CM CLARIFICATION #004

PROJECT: CNE Tahlequah Casino

ADDENDUM # 001

Tahlequah Casino Addendum #01 summary

S1.5
SAFER ROOM
FOUNDATION PLANS

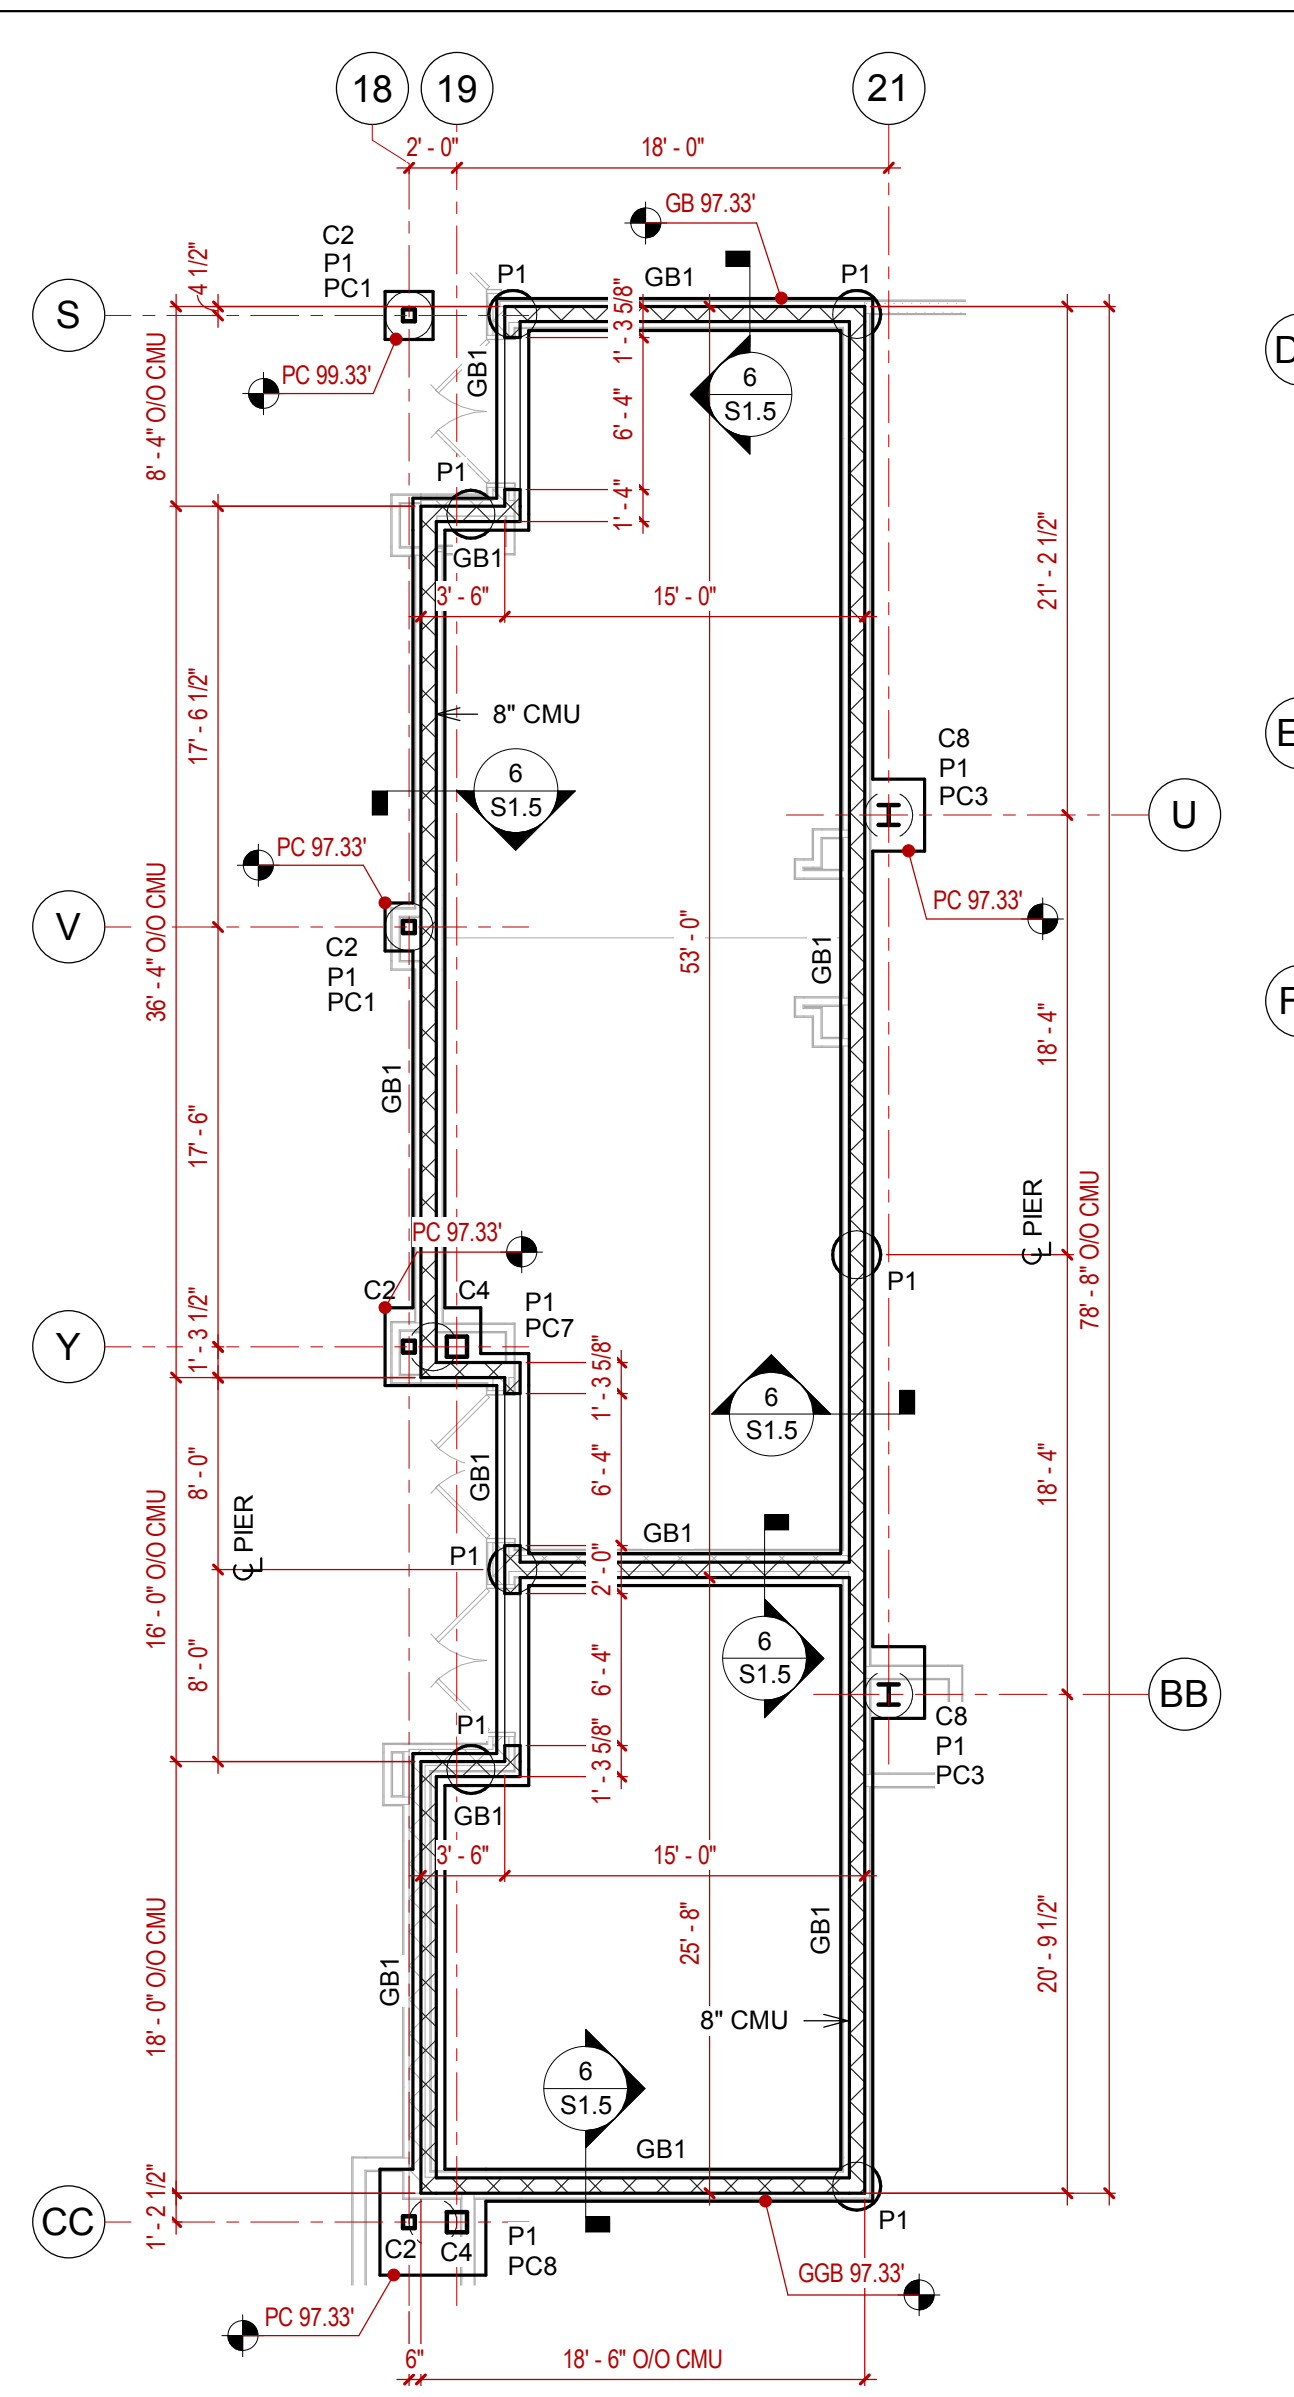
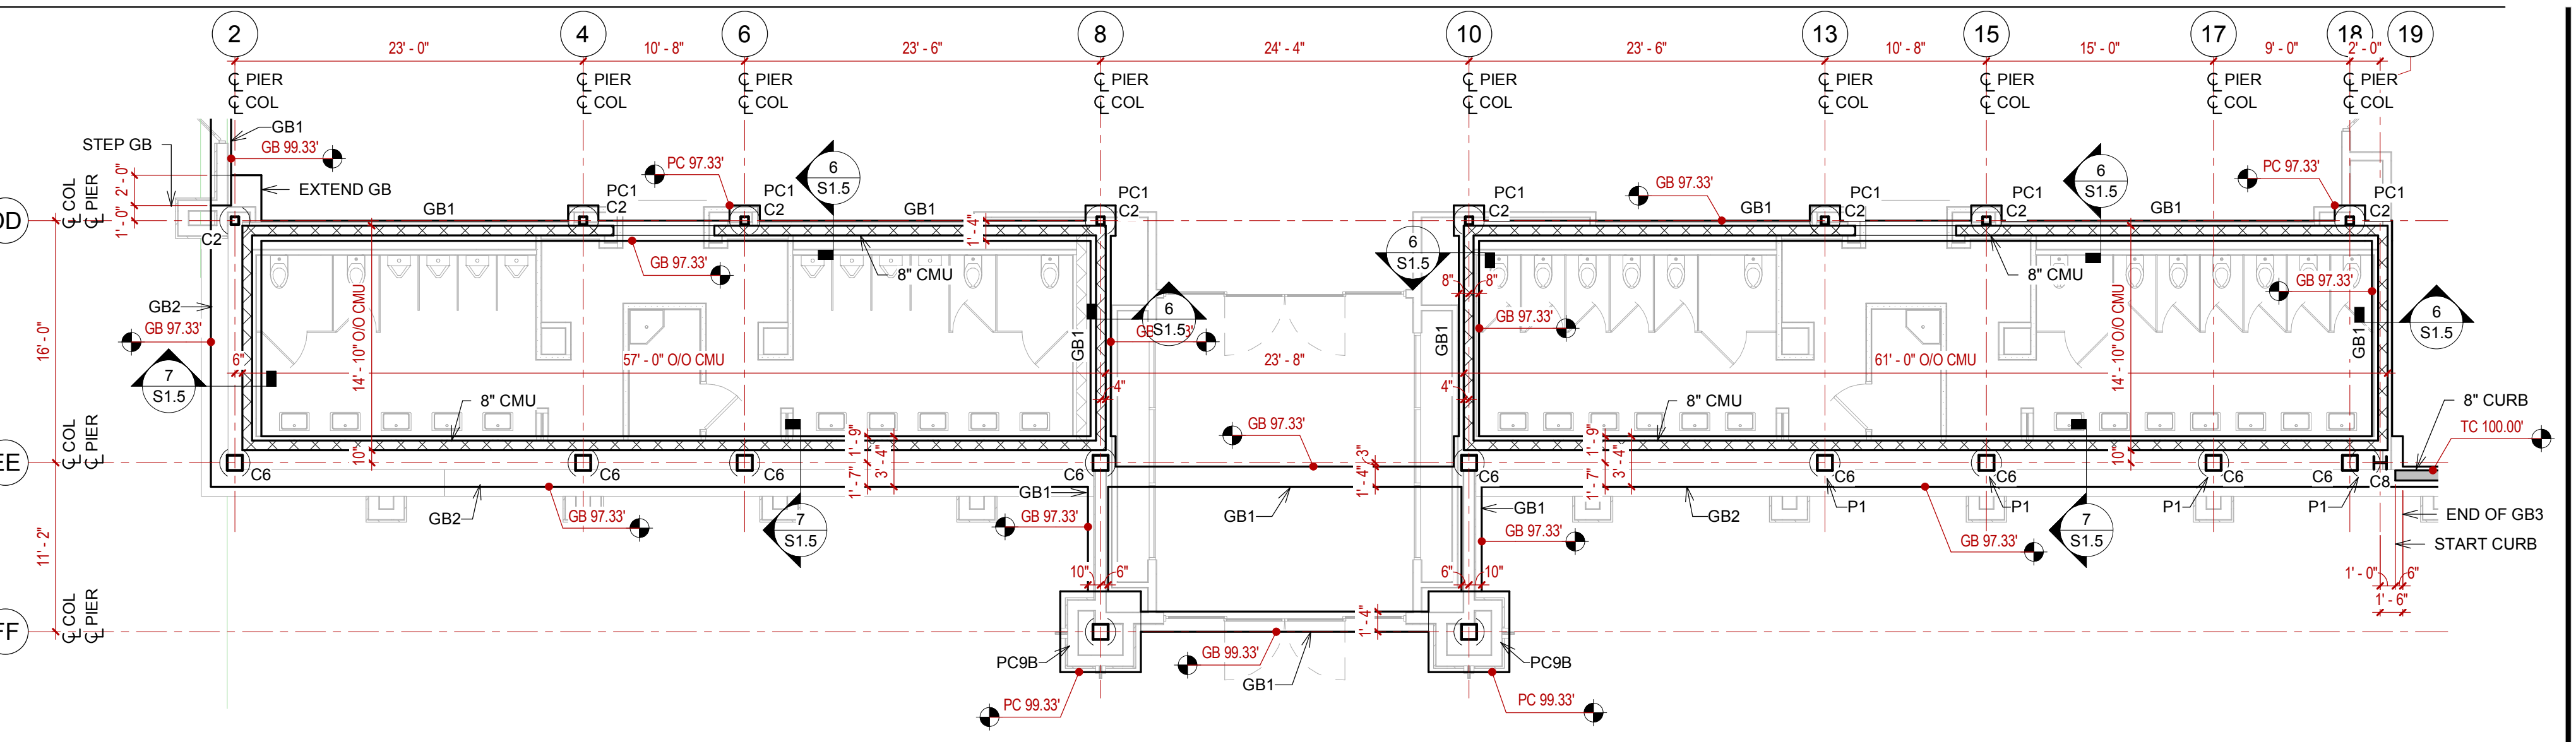
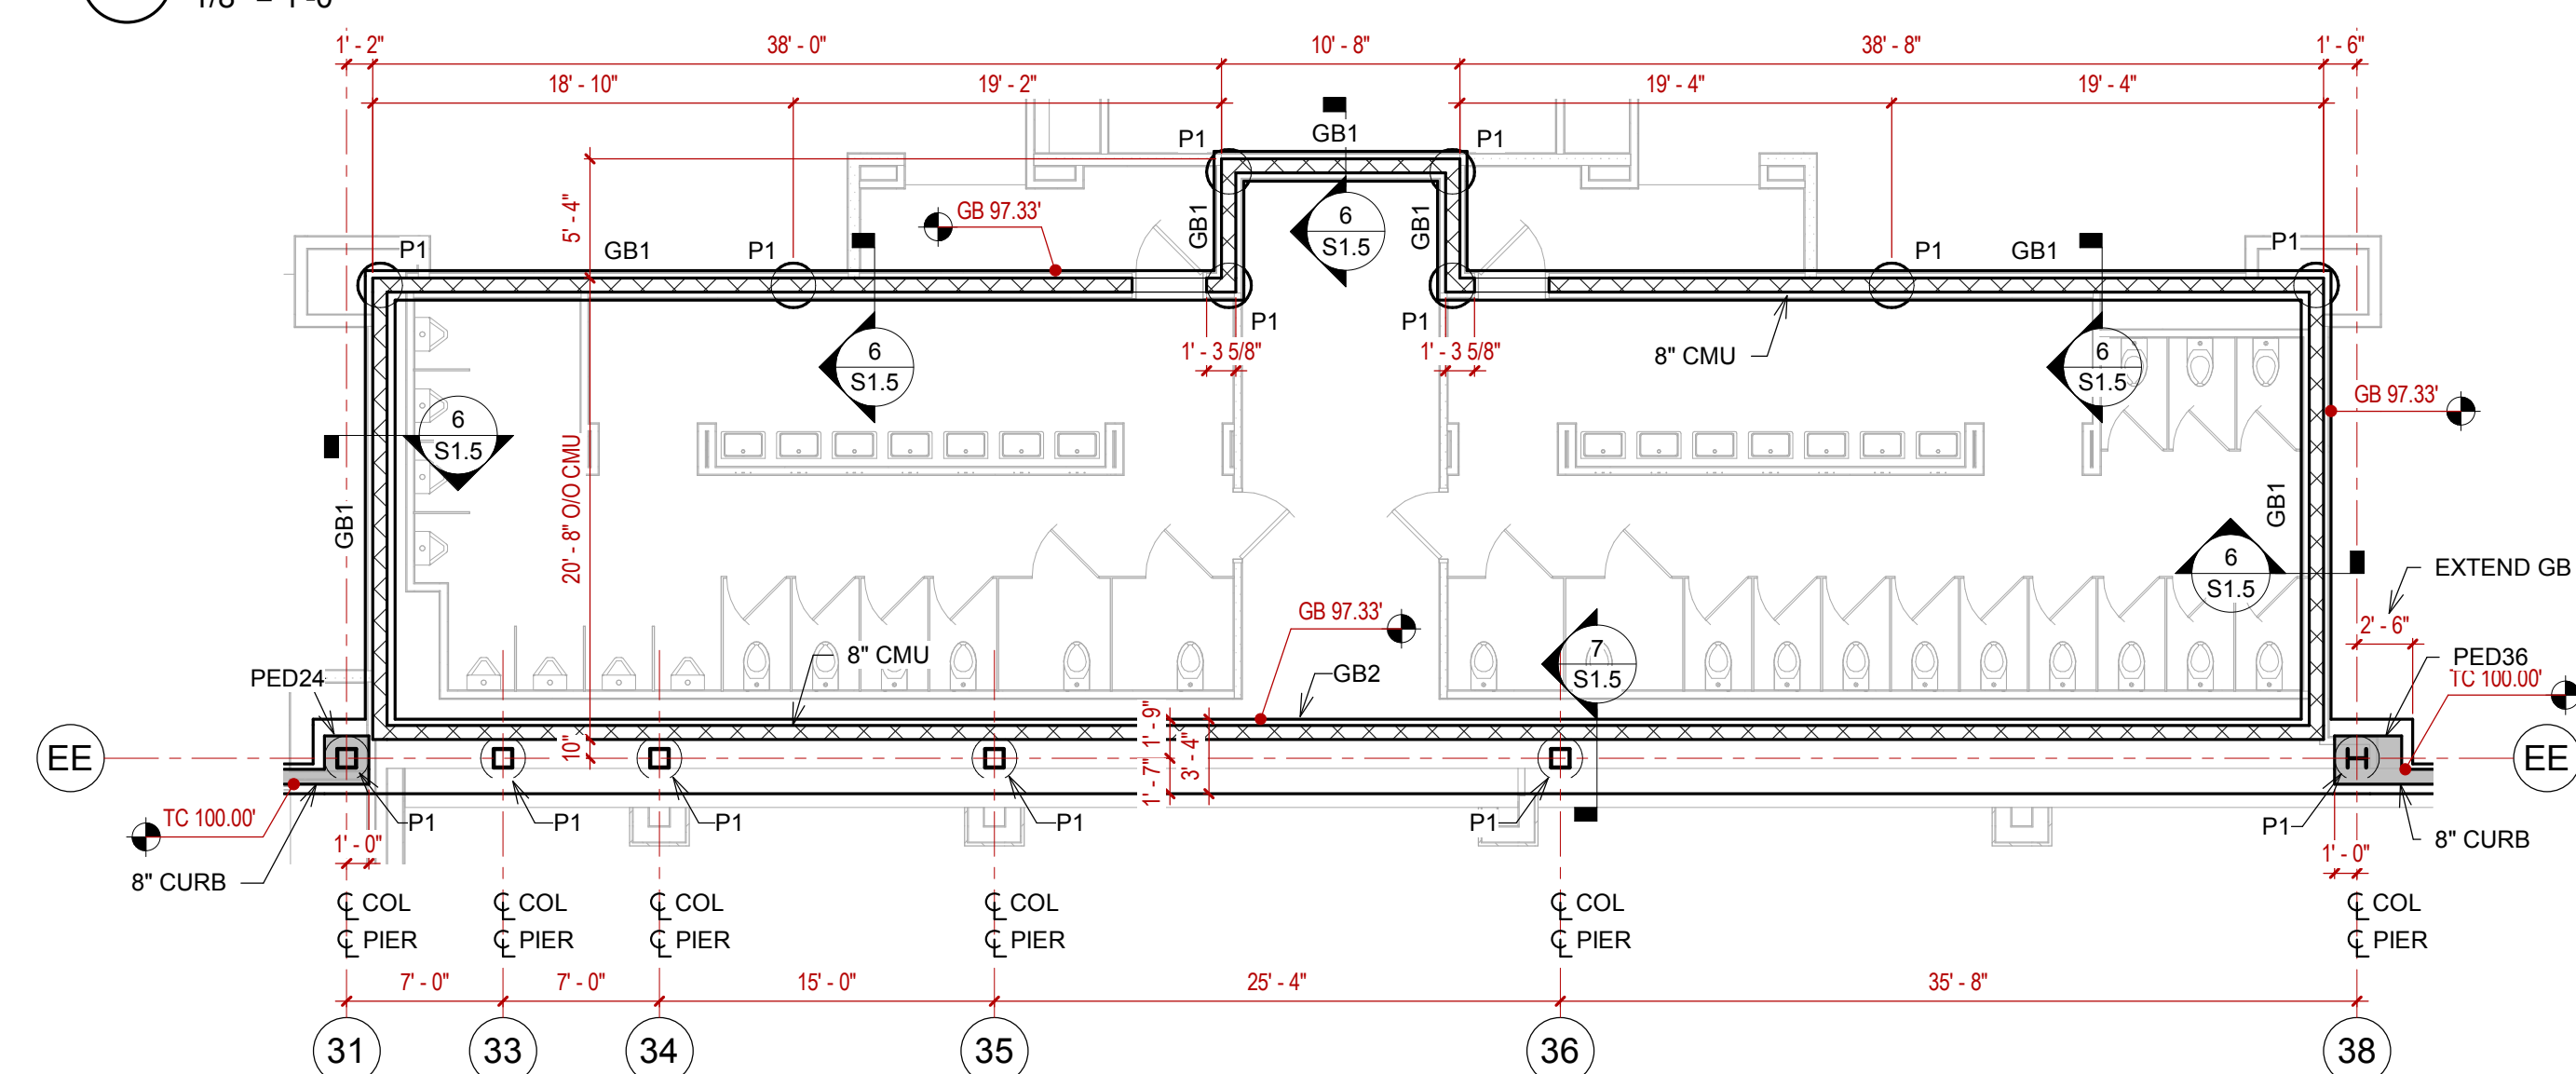
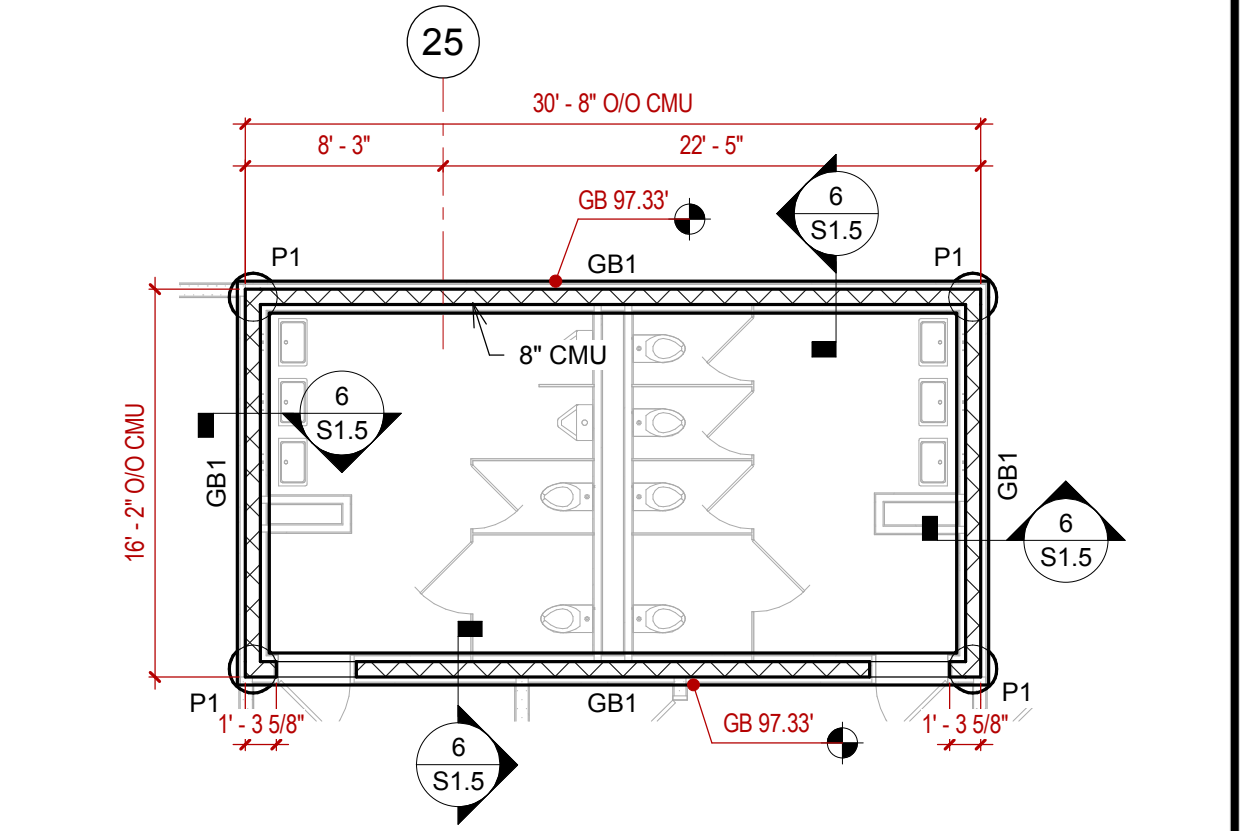
S1.5	Added sheet S1.5
S1.6	Added sheet S1.6
S1.7	Added sheet S1.7
S2.1	<ul style="list-style-type: none"> • Added enlarged stage pit plan and sections. • Added pit for dock levelers.
S3.1	<ul style="list-style-type: none"> • Revised roof deck to galvanize. • Revised column sizes.
S3.2	<ul style="list-style-type: none"> • Moved brace elevation from Y/BB-19 to U/BB-21 • Moved frame line 'DD' 1" east • Revised roof deck to galvanize. • Removed column @ U-19 & U-27.
